July 29, 2008

**SUBJECT: Denison Mines (USA) Corp. (DUSA)  
White Mesa Uranium Mill Cell 4A Operation  
Record of Telephone Conversations and Request for Information**

**B**  
4,6 SECTION  
SLIMES DRAIN HEADER  
SCALE: 1" = 1'

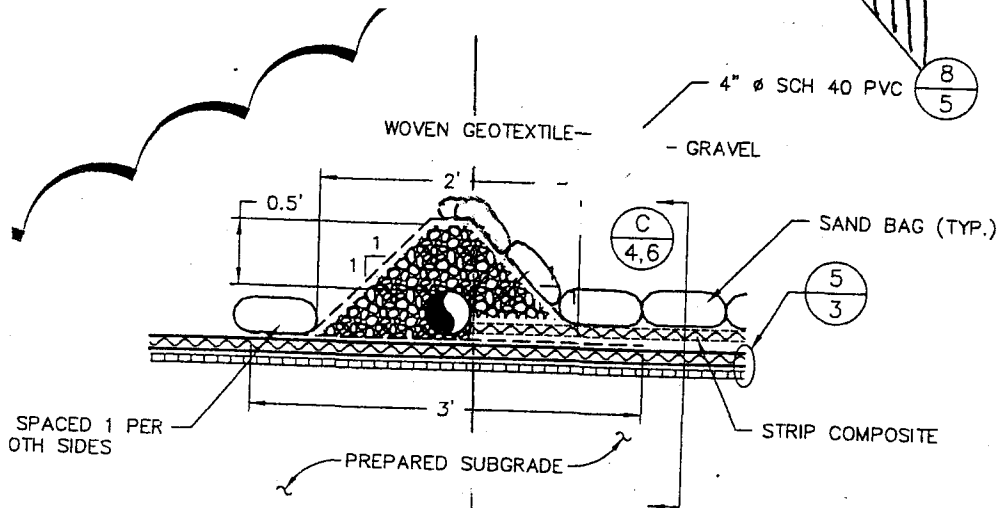
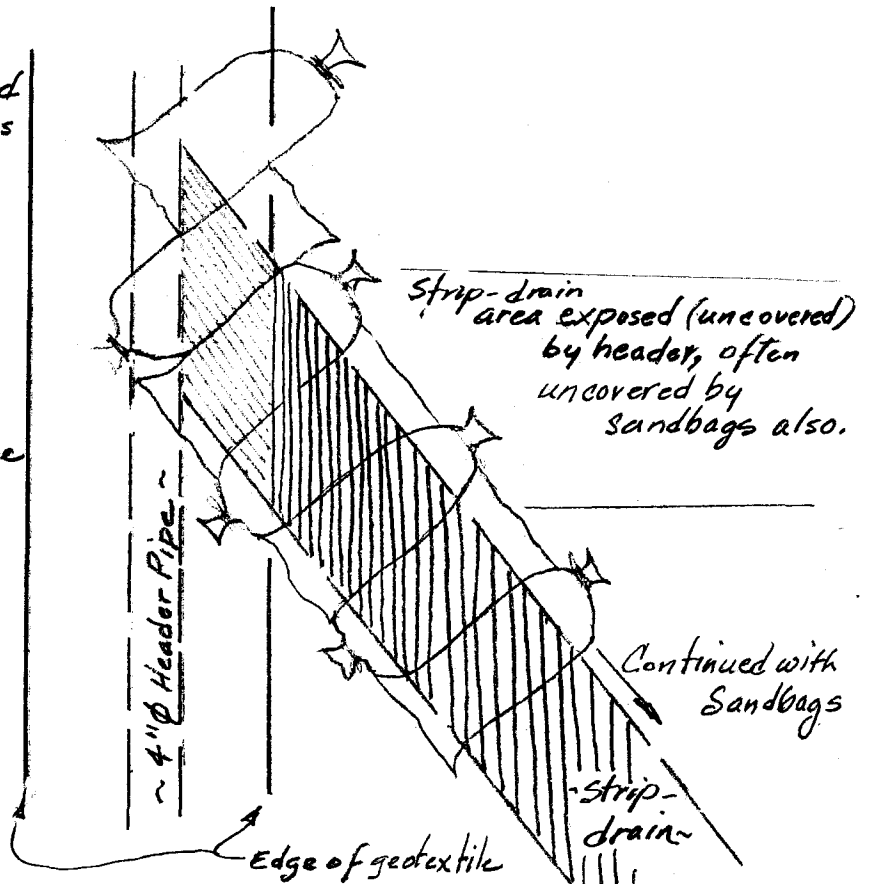
- a.) Sandbag Cover over the Strip-drains:
  - 1.) Sandbags which expose the strip-drain need to be adjusted to cover the same at all locations.
  - 2.) The exposed strip-drains at their junctions with the slimes drain header need to be properly covered with sandbags.
  - 3.) Sandbags need to be extended onto the slimes drain header windrow to cover and be in alignment above the slimes drain sections that are installed within the slimes drain header envelope of geotextile and gravel drain rock. See attached DRC sketch dated July 25, 2008.

Strip-drain  
Area currently to be covered  
by sandbags for filter as  
req'd by specs.

strip-drain area  
to be covered by sand-  
bags and header envelope
